**RE: Request for Informal Review,
Request for Stay of Rock Creek Mine Waste Management Permit and
401 Certification**

This is a Request for Informal Review of the Alaska Gold Company (AGC) Rock Creek and Big Hurrah Mines Project Waste Management Permit 2003-DB0051, and Certificate of Reasonable Assurance pursuant to section 401 of the Clean Water Act. Following is a compilation of issues that we, the undersigned, feel have not yet been adequately addressed by DEC in the permitting process for ACG's Rock Creek and Big Hurrah projects.

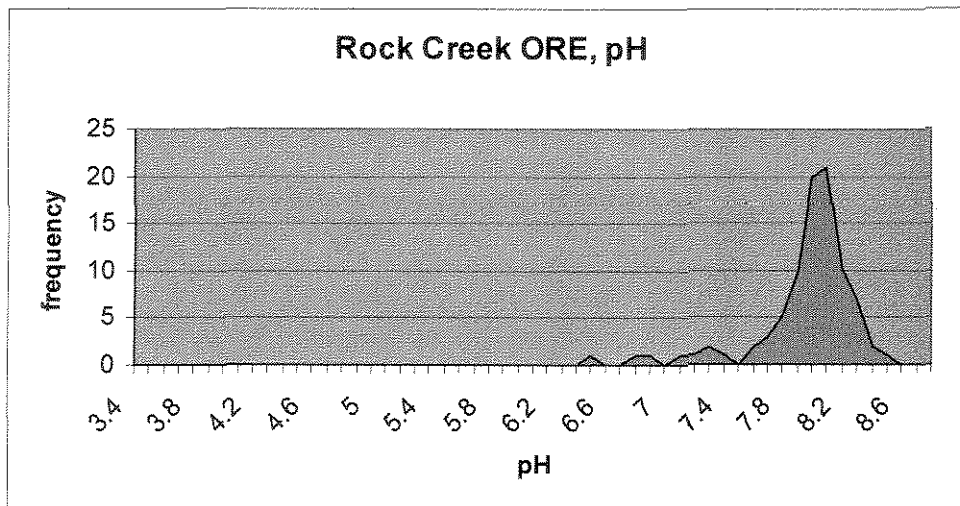
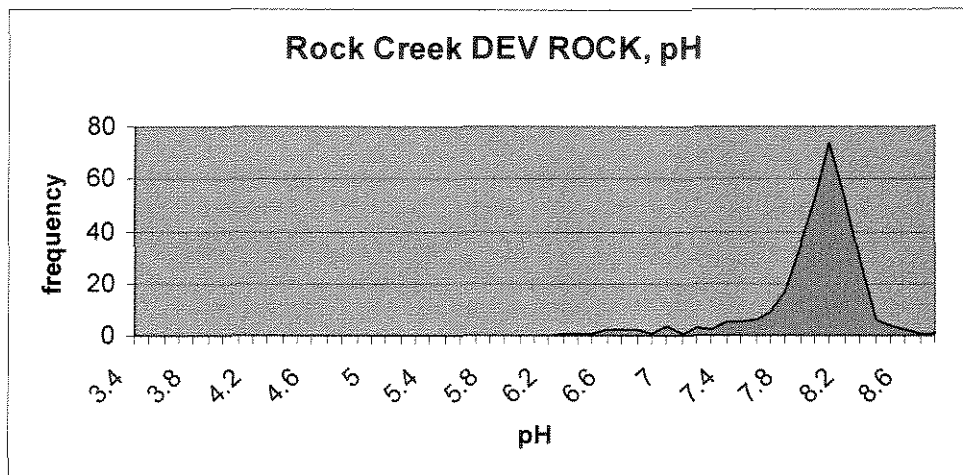
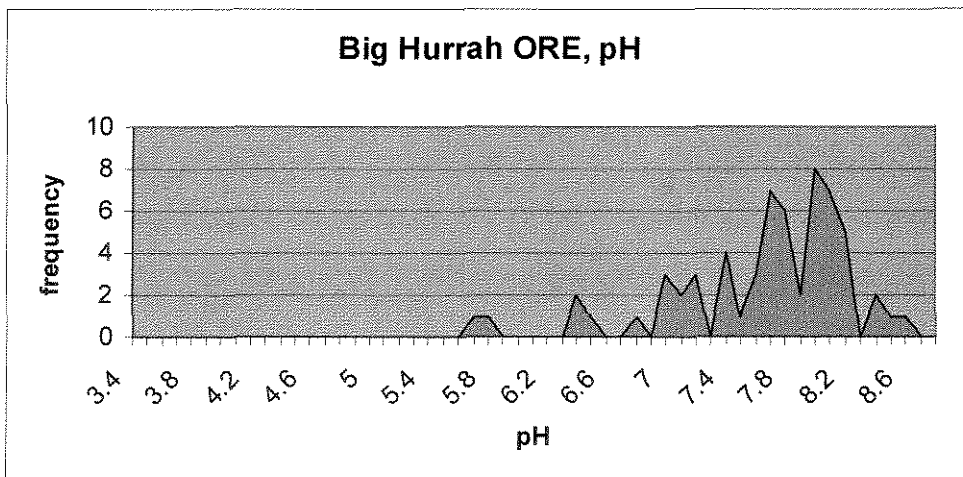
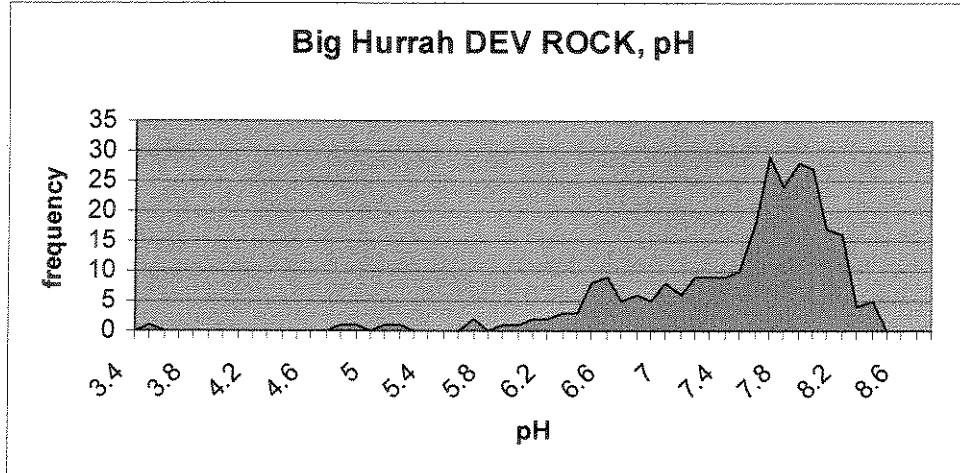
Figures 2 through 5 are frequency diagrams of saturated paste pH of Big Hurrah and Rock Creek ore and development rock. They show a skewed distribution with a majority of measurement between pH 7.8 to pH 8. The presence of acidic material in all rock samples is of concern and may mobilize elemental components in addition to elements that were shown to release immediately such as As, Sb, and Mo.

Our concern regarding PAG material: Merely segregating PAG material at the Big Hurrah site is not an effective measure to reduce the possibility of oxidation. In fact leaving the material as proposed is the most likely way to oxidize the PAG material. Deposition of PAG material in water may flush already oxidized contaminants such as As and Sb, however, that could take a very long time until the rock becomes dissolved or stable.

Figures 6 through 9 come from Volume 4 and 8 and show the spatial orientation of drill samples and pit locations.

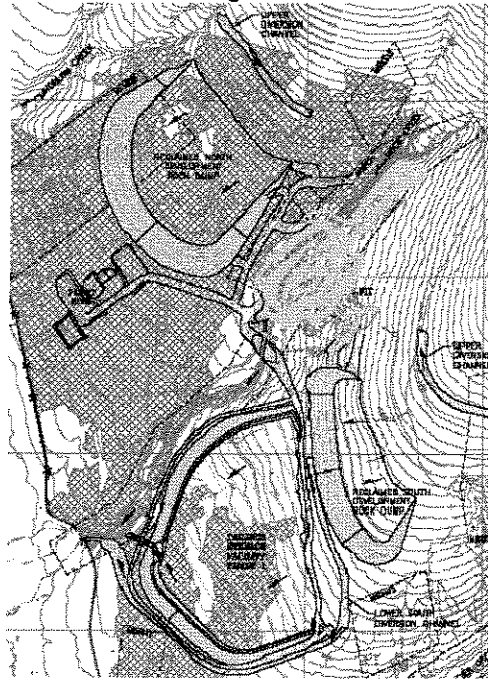
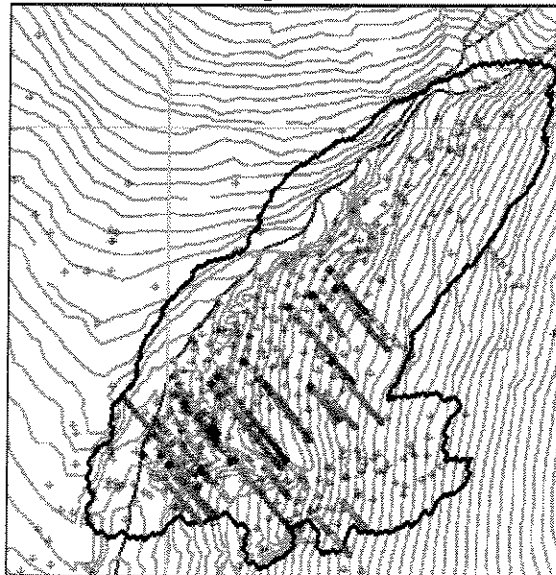
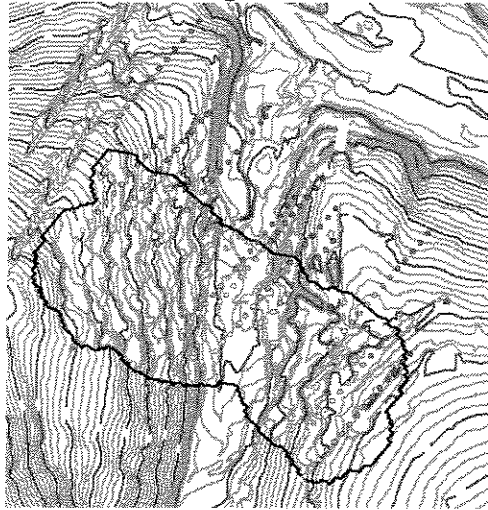
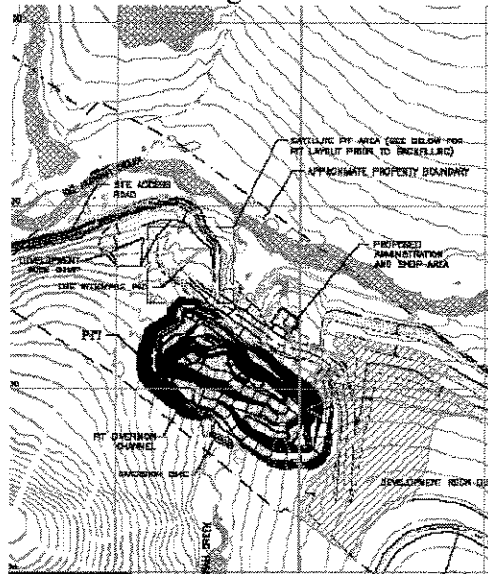
Our concern regarding drill depths: The drill sample locations do not cover the entire area of the pit locations at Big Hurrah or Rock Creek. It is typical to include not only the entire area of the proposed pit in the sampling data, but also an additional 30 meters or so beyond the proposed pit boundary, since this material will form the walls of the pit on closure, and will also be subject to leaching due to blast fracturing. In addition, many of the samples at Big Hurrah were not taken from the rock to be mined. See Figure 8 above. This could potentially bias the data toward less potentially acid generating averages. DEC should address how the drill locations were placed in relation to the pits and adjust the permit or reverse it decision. Like the sample depths a power analysis should be done

Figures 21 through 51 show elemental concentrations of various elements which were shown to release from Rock Creek HCT tests. The graphs were constructed from geochemistry data from Volume 8.

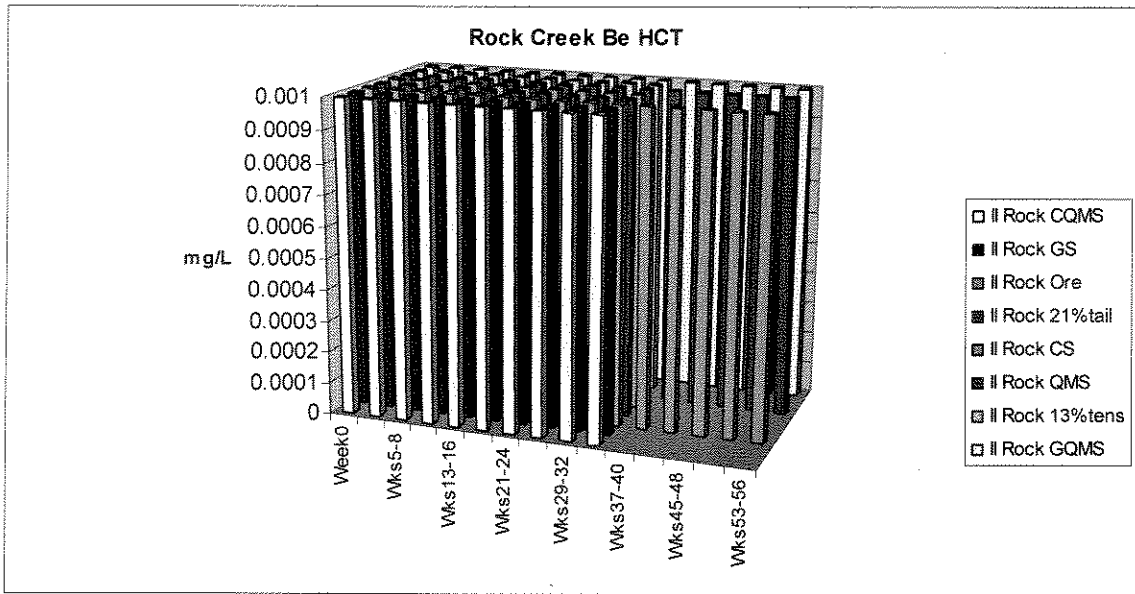
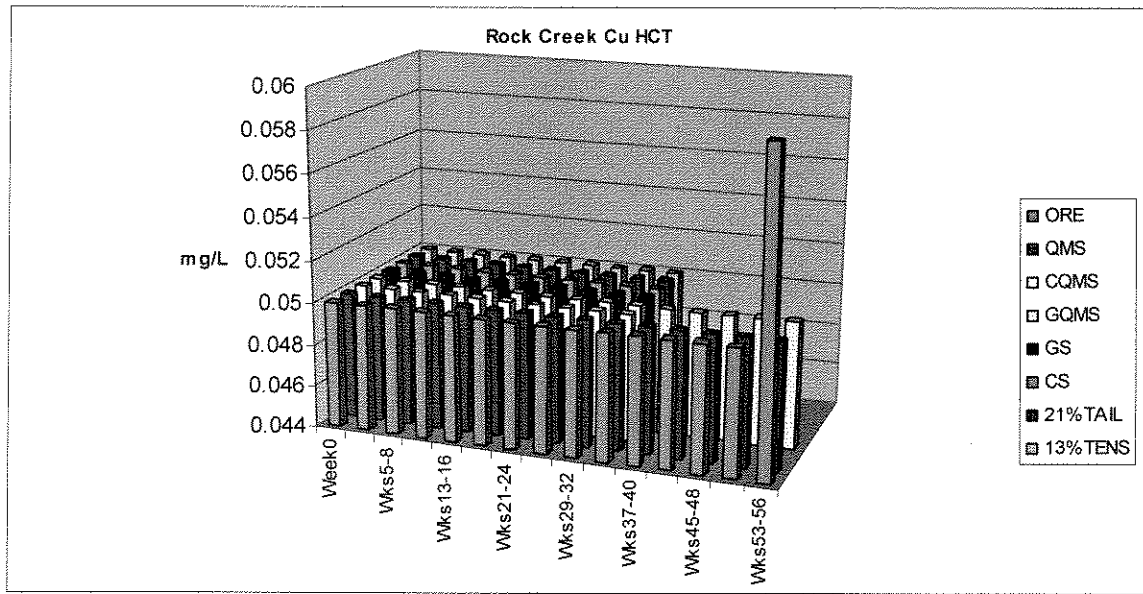
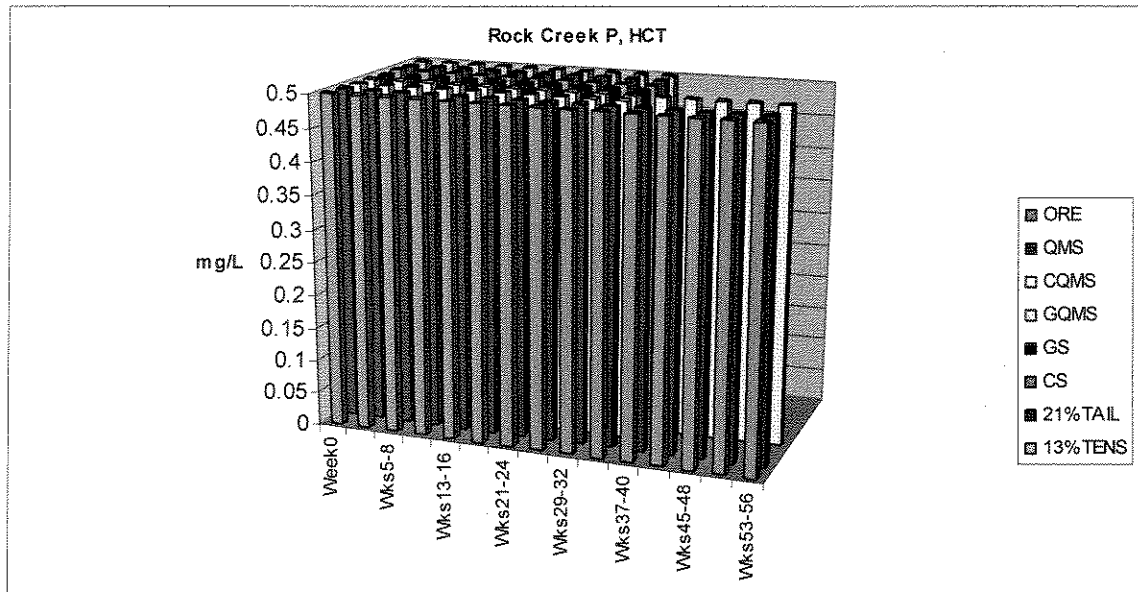
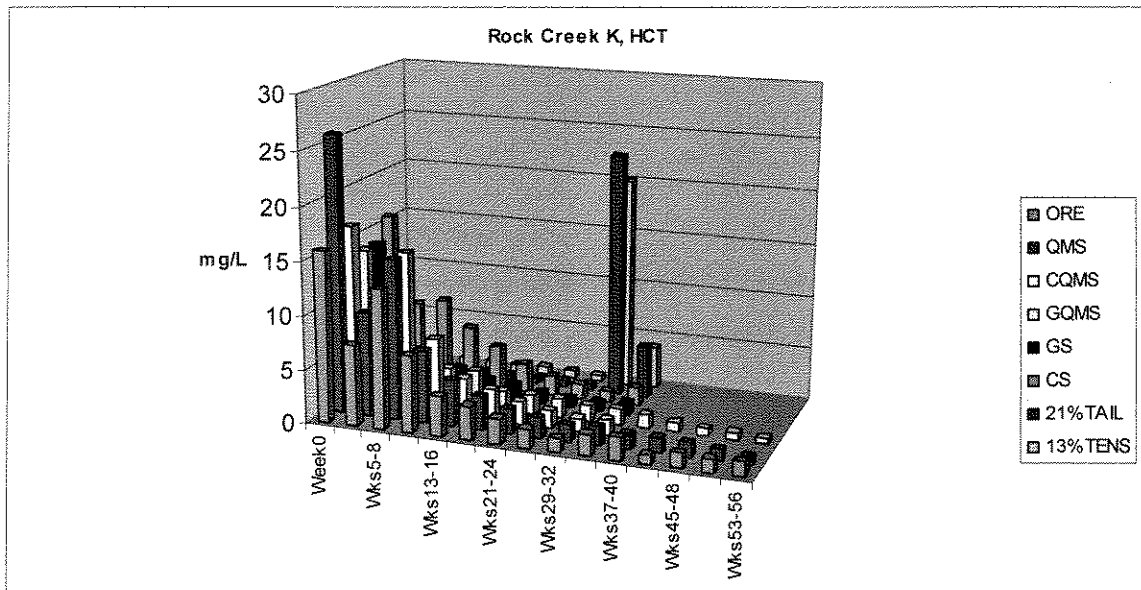
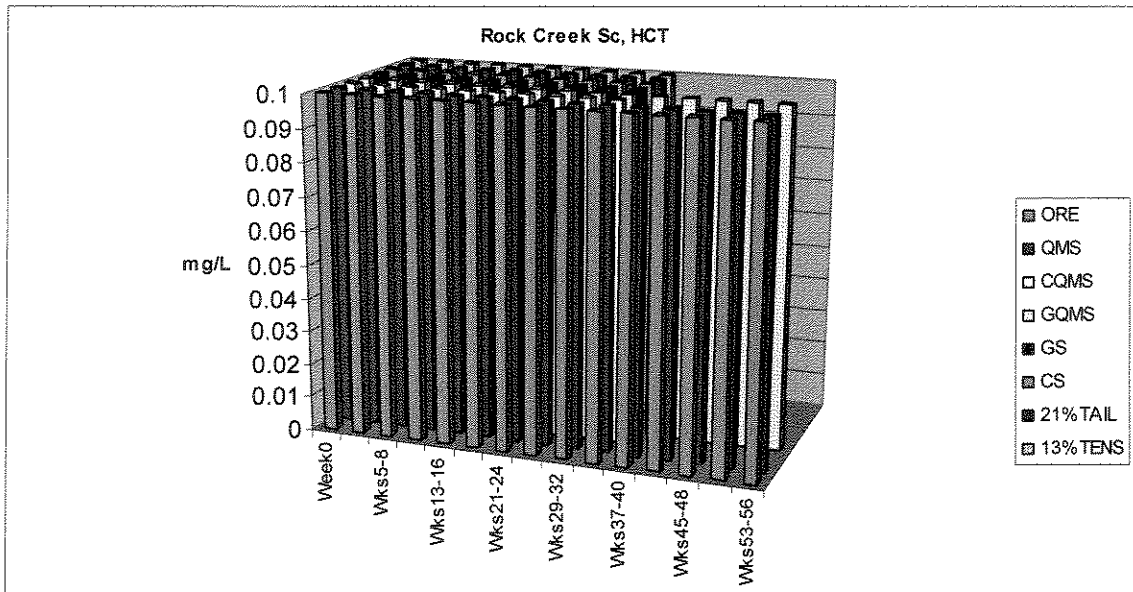
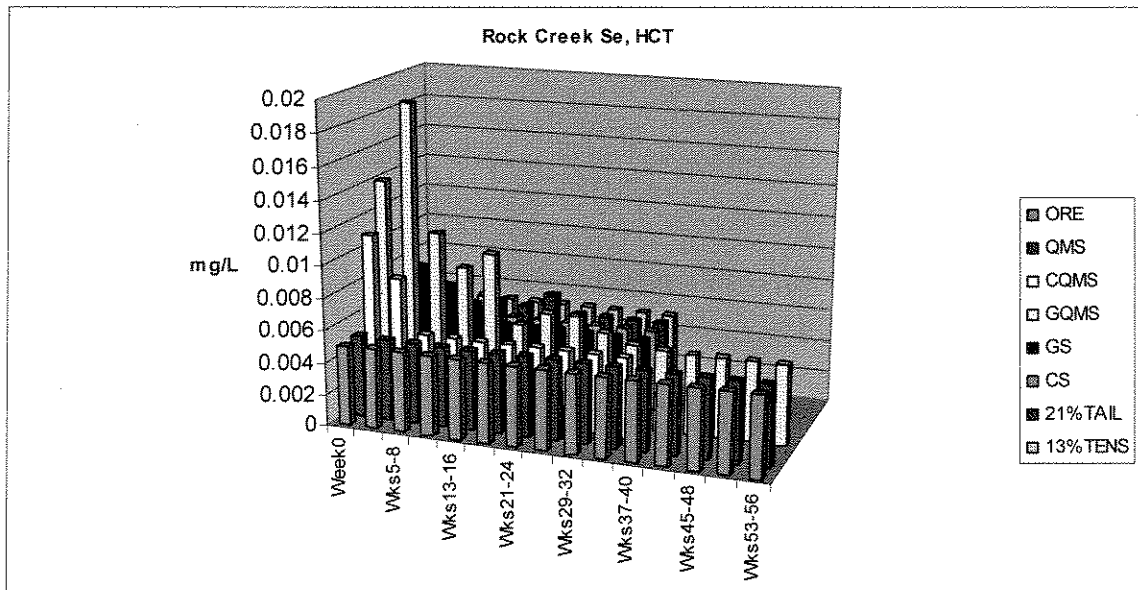
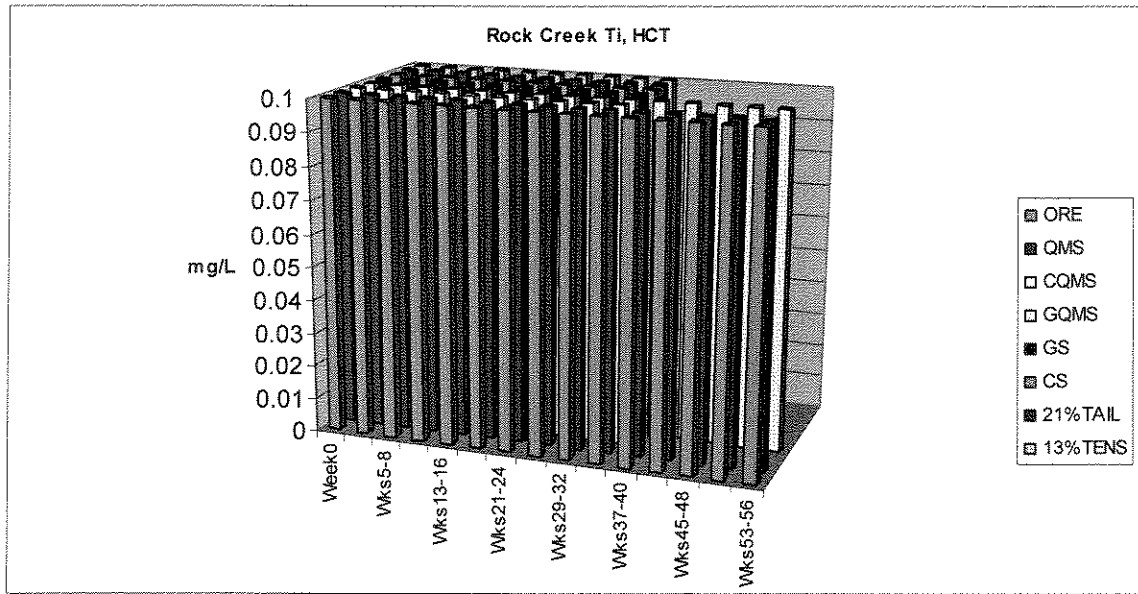
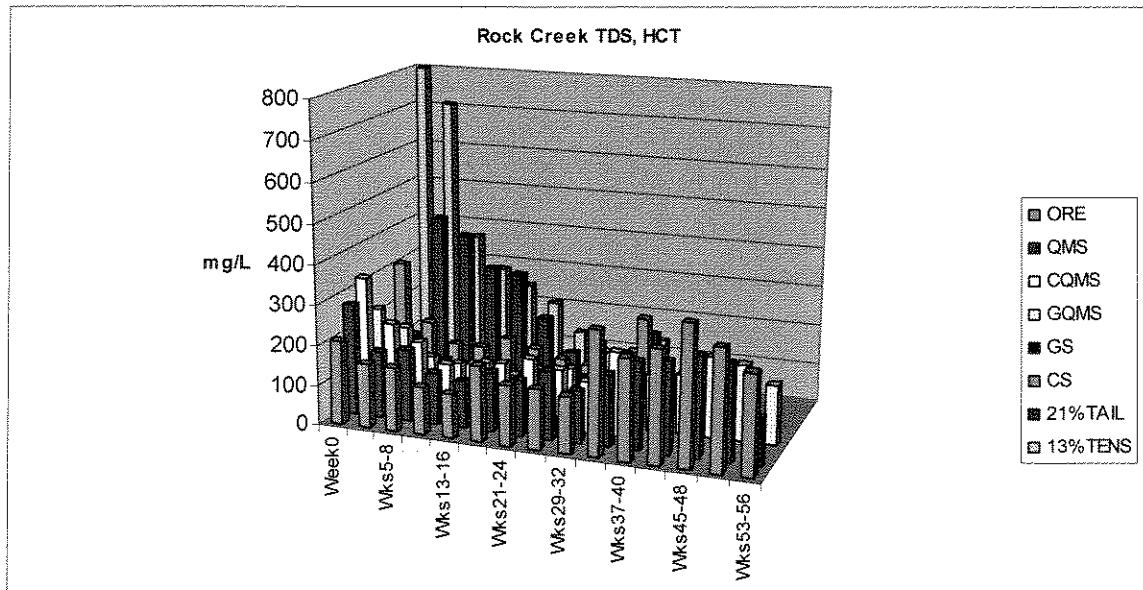
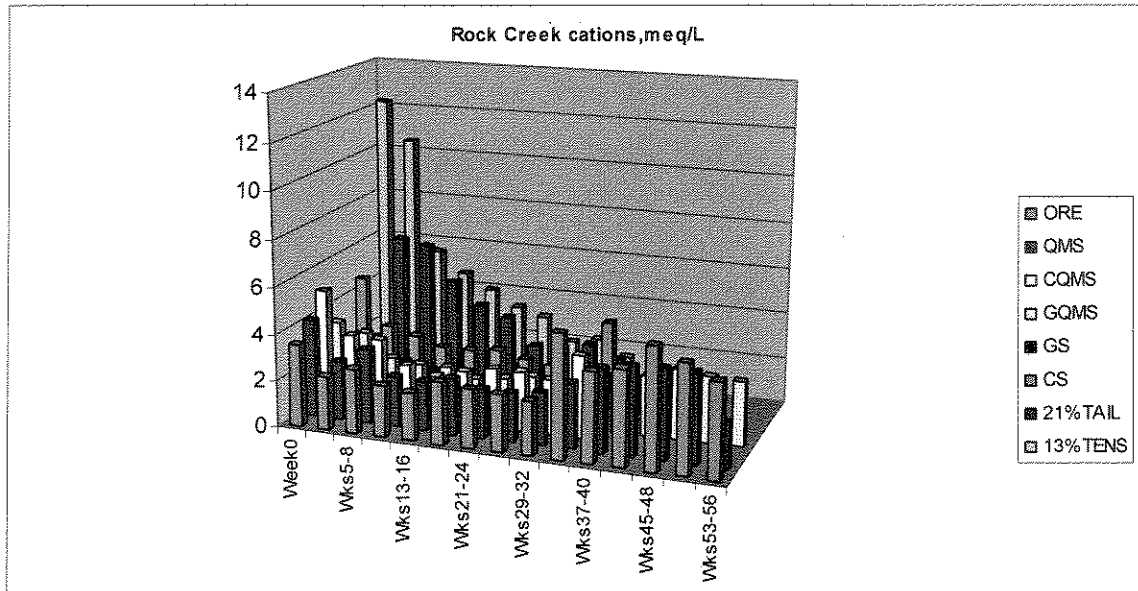
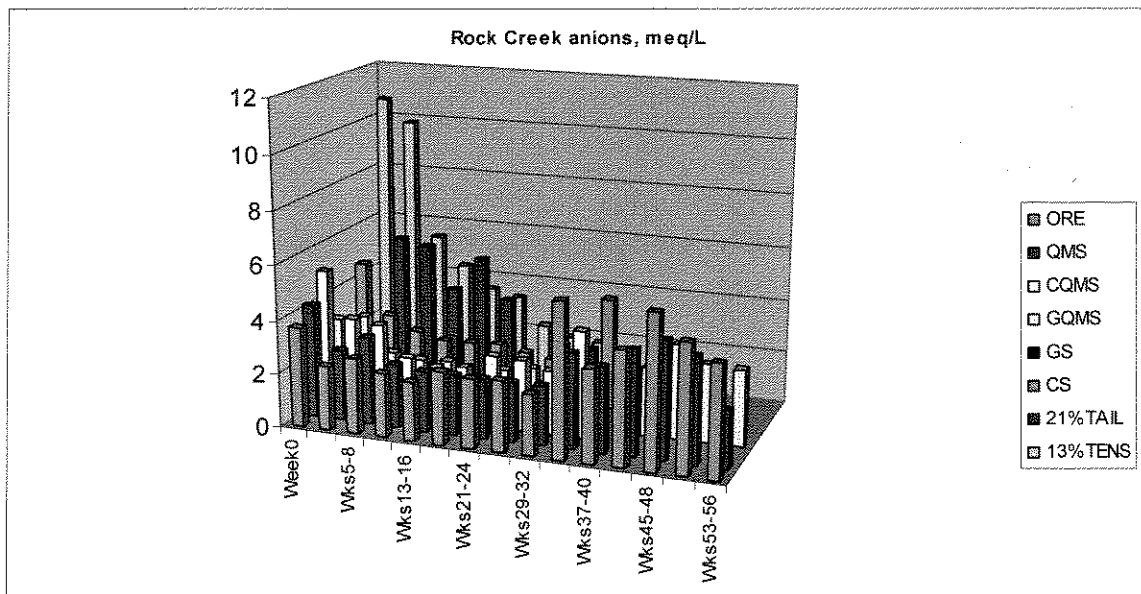
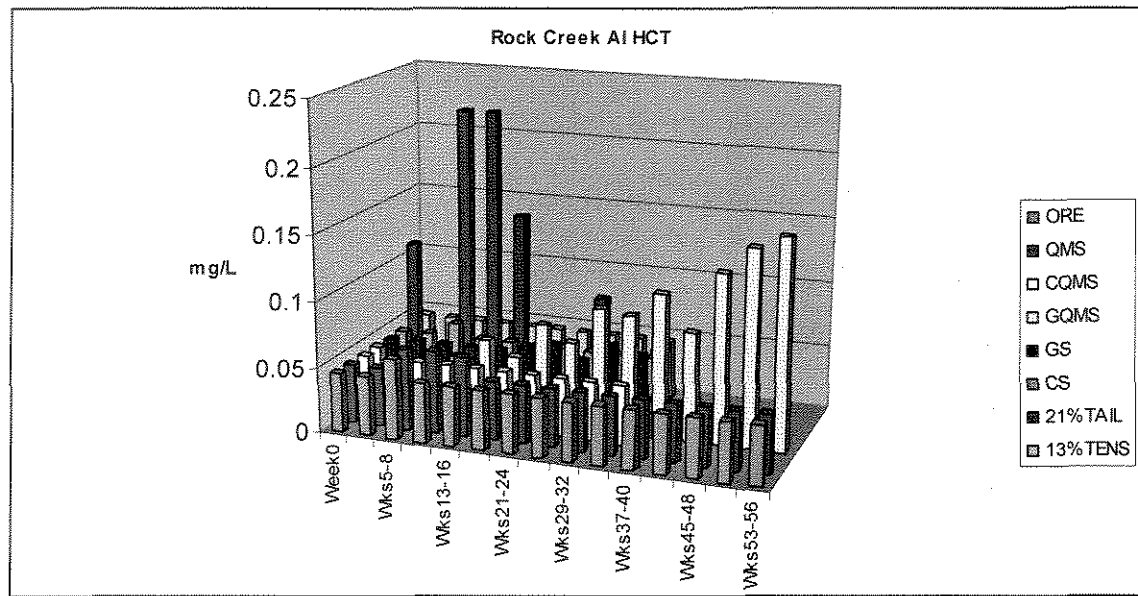
All of the elements in the above graphs are listed with the Agency for Toxic Disease Registry (ATDR), the Regulations and Advisories for Ba, Be, B, Cd, Cr, Co, Cu, Cyanide, Pb, Mn, Hg, Ni, Se, Sr, Tl, Sn, V, Zn, & Al. It appears that the TSF may be highly contaminated with regulated elements or substances and TSF monitoring must include an adequate chemical assessment for all listed elements. The pit lake will likely also contain many of those listed elements. The regulated and listed elements pose a risk to plant, animal, and human life through accumulation.

Our proposed alternative: The ATDR has published standards for dosage and exposure, and DEC should adopt permit conditions that address those dosage or exposure standards. We request that DEC also require daily chemical assessment in the TSF of the listed elements and compounds.
